**IN THE MATTER OF THE
REQUEST FOR FINAL PLAT
CONSISTING OF 52 BUILDING
LOTS AND 13 COMMON LOTS ON
14.04 ACRES OF LAND IN THE R-8
ZONING DISTRICT FOR
SPRINGDAY SUBDIVISION NO. 1**

CASE NO. FP-2026-0019

**ORDER OF CONDITIONAL
APPROVAL OF FINAL PLAT**

SUBJECT: Springday Subdivision No. 1
FP-2026-0019

FINAL PLAT OF SPRINGDAY SUBDIVISION NO.1

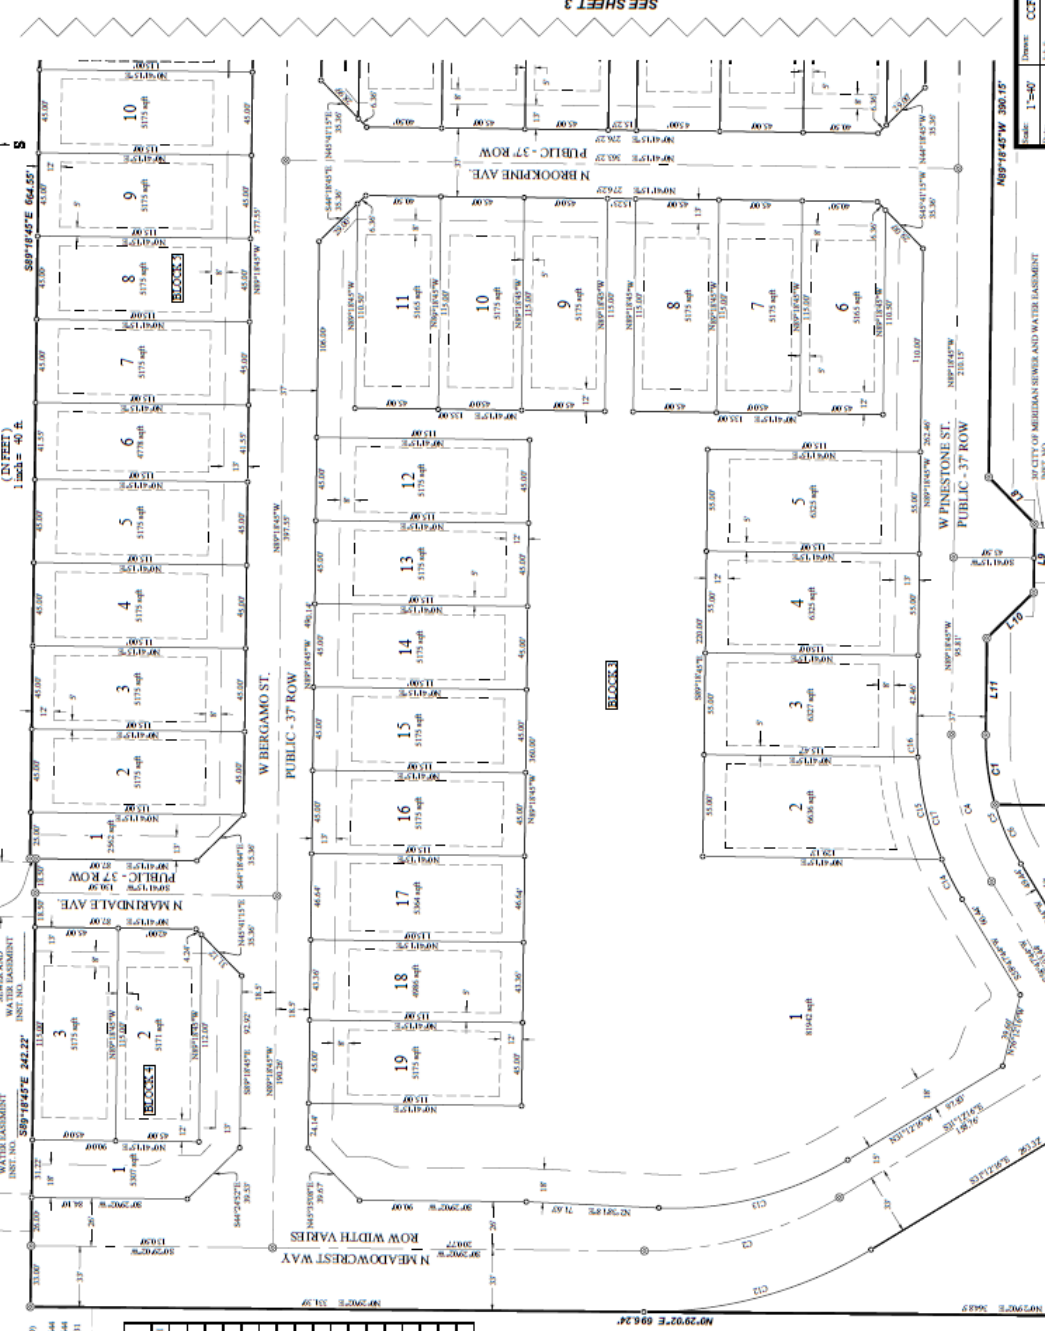
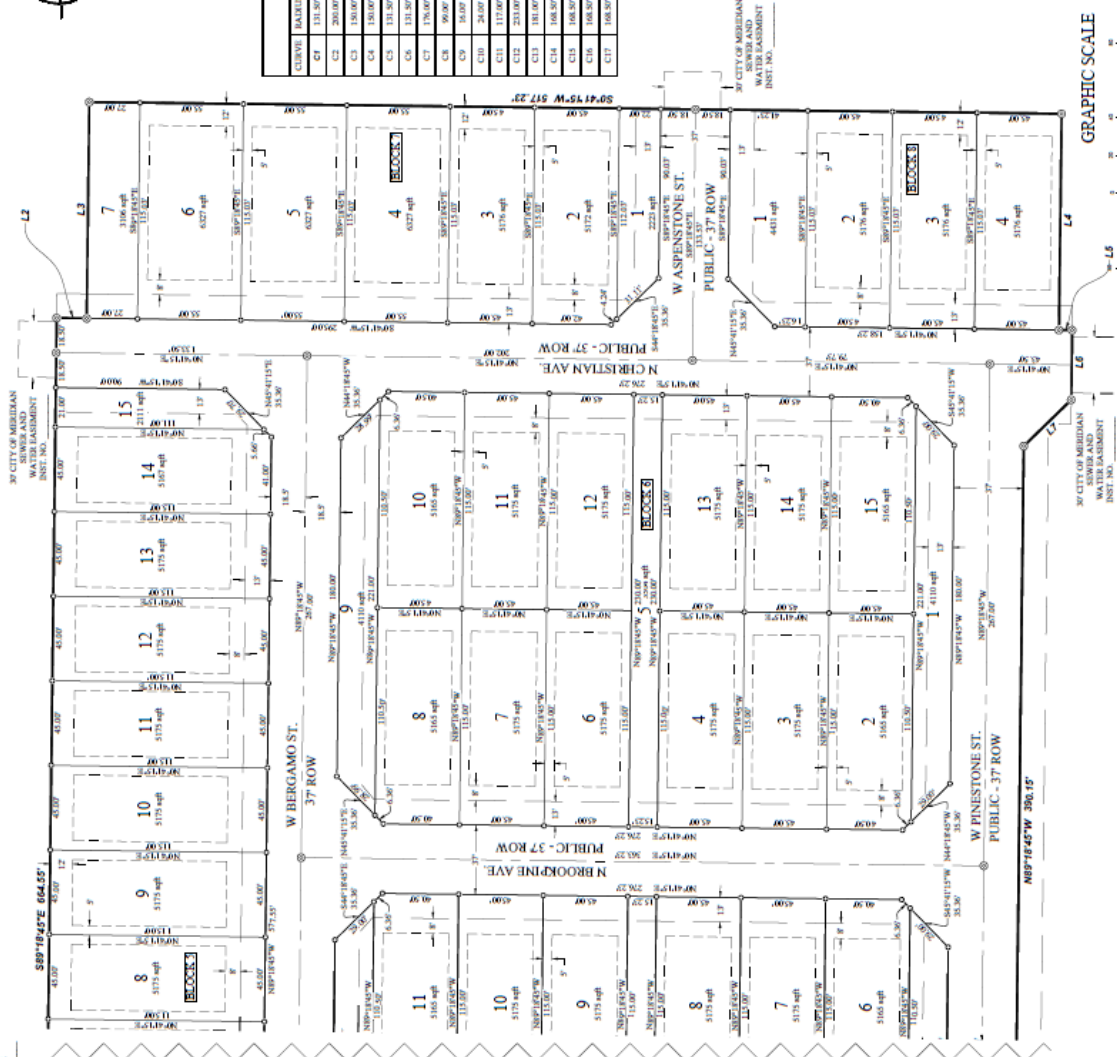
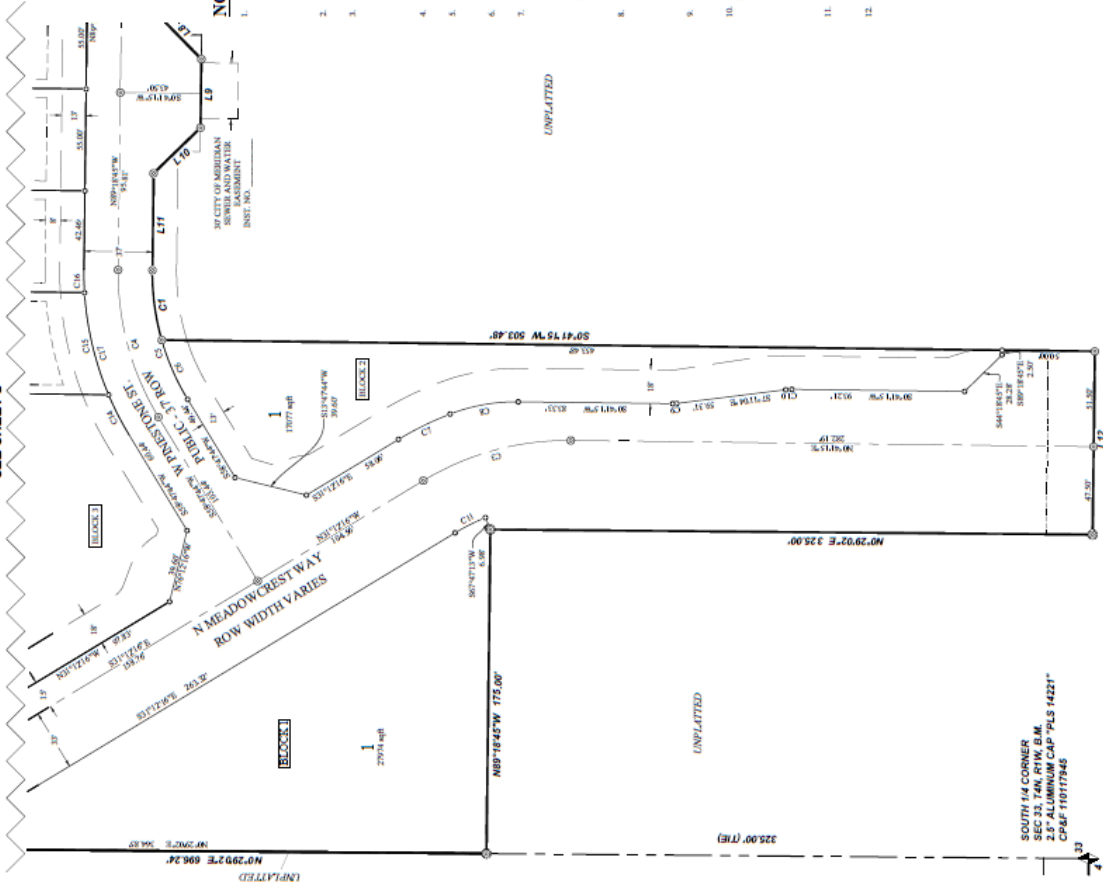
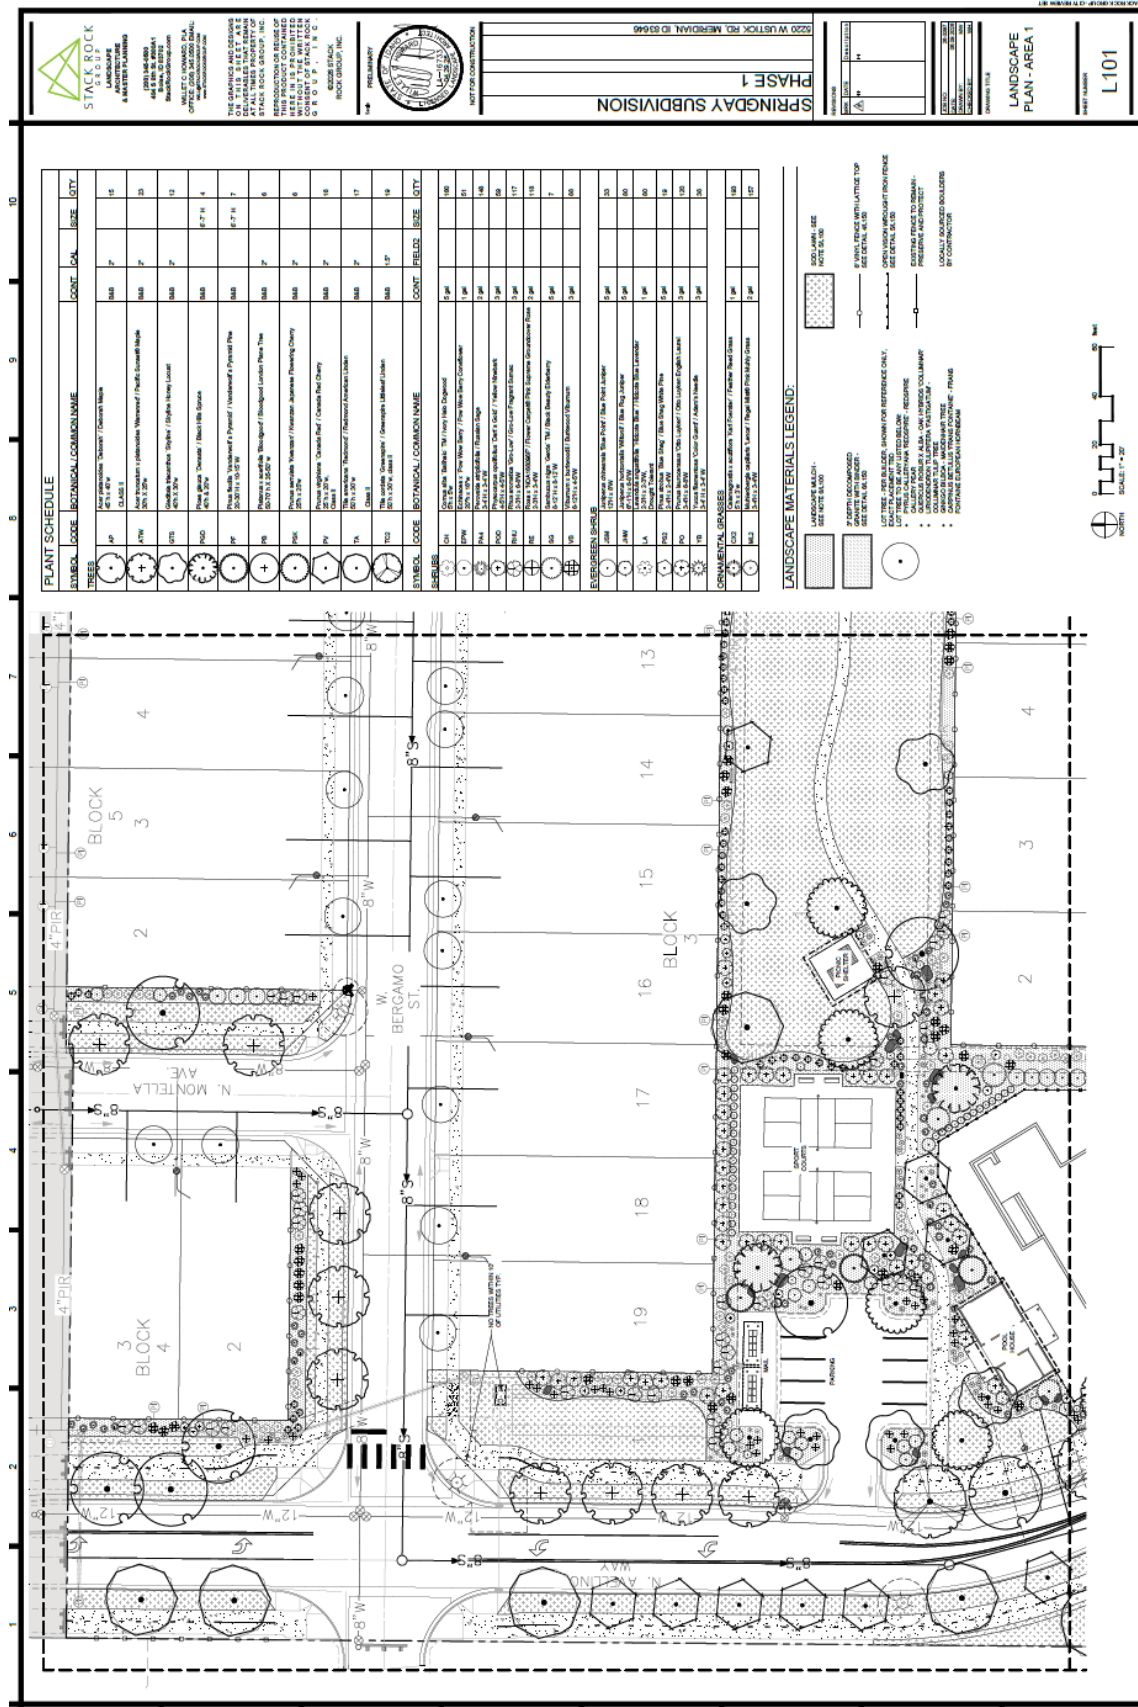
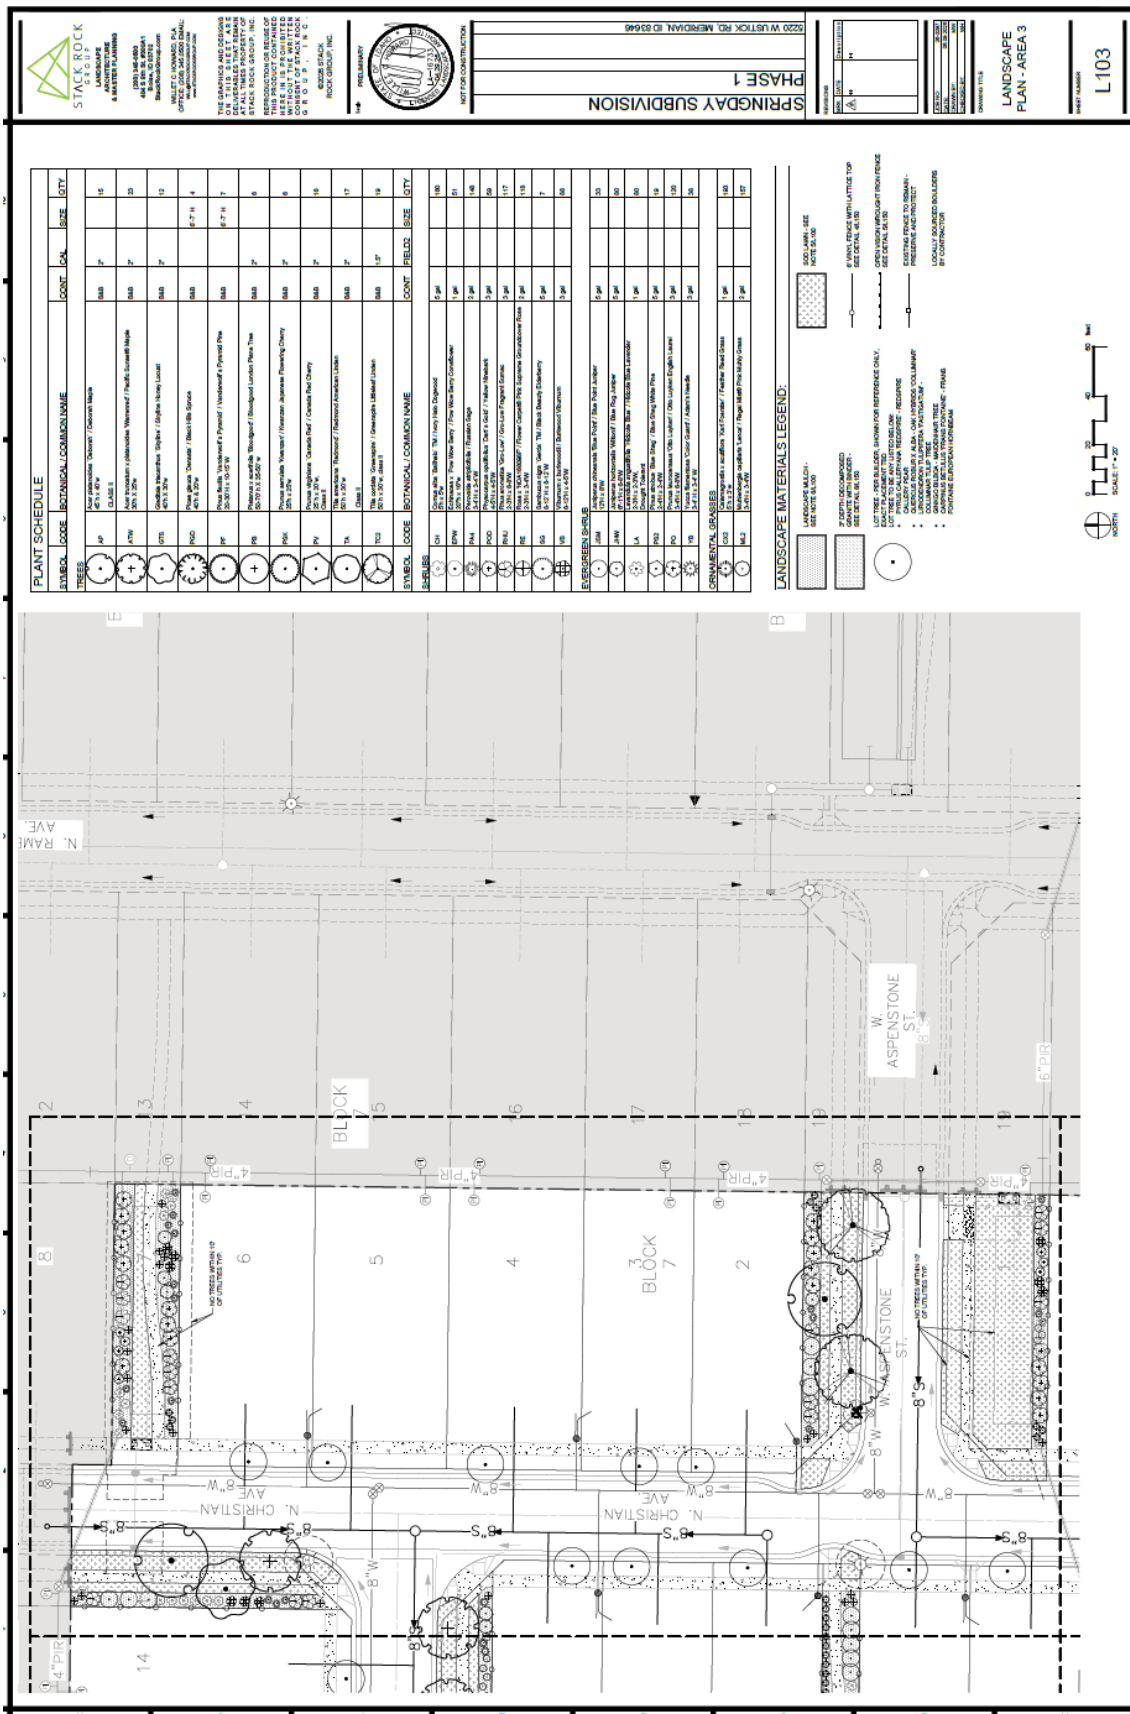
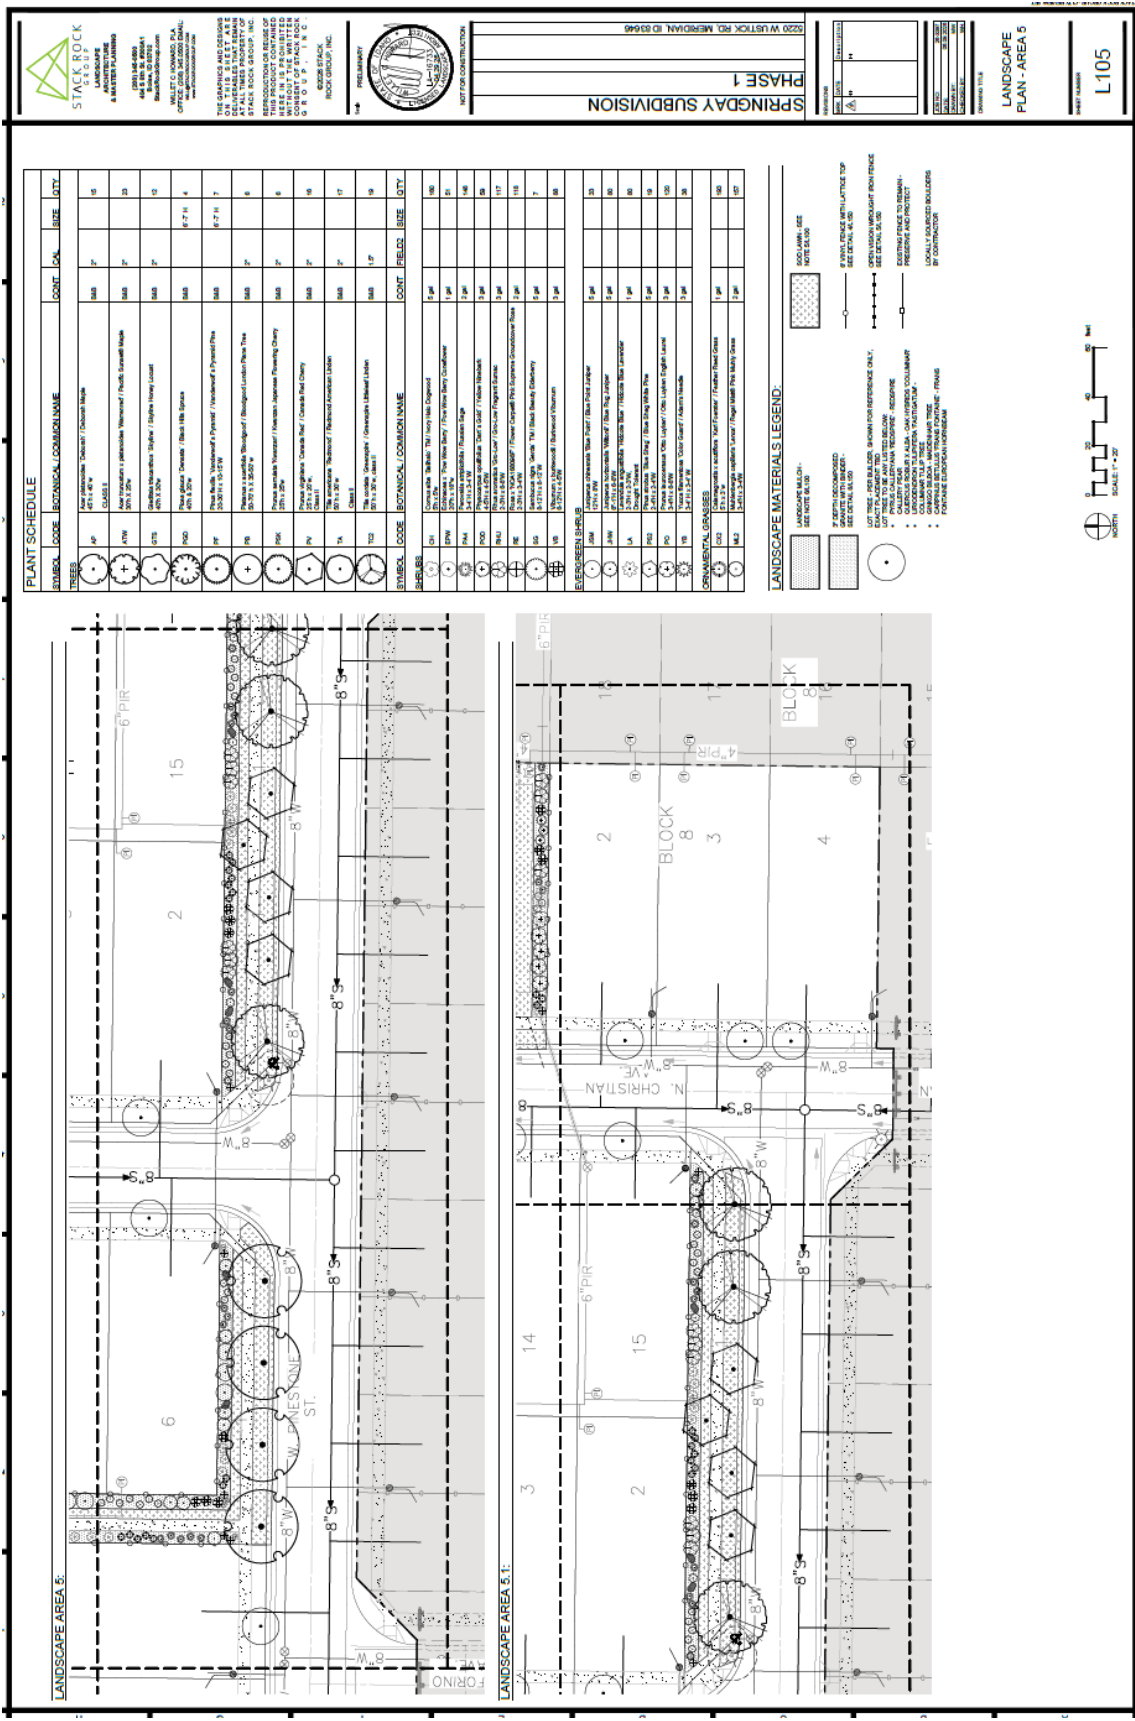
3. Prior to submittal for the City Engineer's signature, have the Certificate of Owners and the accompanying acknowledgement signed and notarized.
4. The final plat prepared by Focus Engineering and Surveying, LLC, dated: 05/28/2026, included in Section V.B shall be revised as follows:

- a. In the Legend, include the recorded instrument numbers of the City of Meridian and water easement & the ACHD permanent easement.
 - b. Include the CP&F numbers on Sheet 1 at the northwest and southwest corners of the site.

- c. Include the City of Meridian sewer and water easement instrument numbers graphically depicted on the plat.
 - d. Note #11: Include the recorded instrument number of the ACHD temporary license agreement.

A copy of the revised plat shall be submitted with the Final Plat Mylar application for City Engineer signature.
